# Access Compliance Report

## Public Rights-of-Way

Intersection ID: 5808	Main Street: FOREST_POND_DR	Cross Street: NEVIN_RD	Location: SW
ADA ID: 498B6ADD0002	Ramp Type: Perp	Initial Pass/Fail: Fail	Overall Compliance: No
		Severity Score: 25

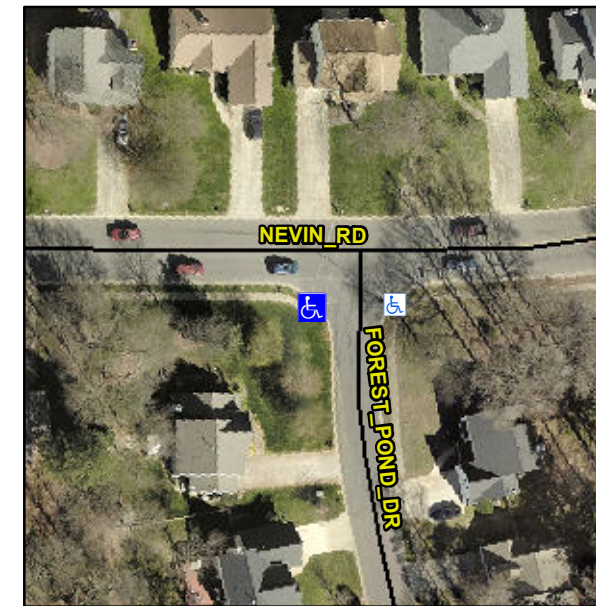
**Not Found, R304.5.3**

Compliance	Description	Data	Compliance	Description	Data
N/A	Ramp Length (in)	99.0	Yes	Ramp Slope (%)	6.7
Yes	Ramp Width (in)	48.0	No	Ramp XSlope (%)	7.7
N/A	Flare Type LT	N/A	N/A	Flare Type RT	N/A
N/A	Flare Slope LT (%)	N/A	N/A	Flare Slope RT (%)	N/A
N/A	Flare Traversable LT?	N/A	N/A	Flare Traversable RT?	N/A
N/A	Landing Length (in)	N/A	N/A	DWS Provided?	N/A
N/A	Landing Width (in)	N/A	N/A	DWS Contrast?	N/A
N/A	Landing Slope (%)	N/A	N/A	DWS Length (in)	N/A
N/A	Landing X Slope (%)	N/A	N/A	DWS Full Width?	N/A
N/A	Landing Curb? (Y/N)	N/A	N/A	DWS Offset (in)	N/A
N/A	Shared Landing?	N/A			
N/A	Gutter Ponding?	N/A	N/A	Gutter Slope (%)	N/A
N/A	Gutter Lip Ht (in)	2.0	N/A	Gutter X Slope (%)	N/A
N/A	Painted X Walk1?	No	N/A	Painted X Walk2?	N/A
	X Walk 1 Direction	To E		X Walk 2 Direction	N/A
N/A	X Walk 1 Width (in)	N/A	N/A	X Walk 2 Width (in)	N/A
	X Walk 1 Slope (%)	2.5		X Walk 2 Slope (%)	N/A
	X Walk 1 X Slope (%)	4.4		X Walk 2 X Slope (%)	N/A

**Remove & Replace Entire Ramp.**
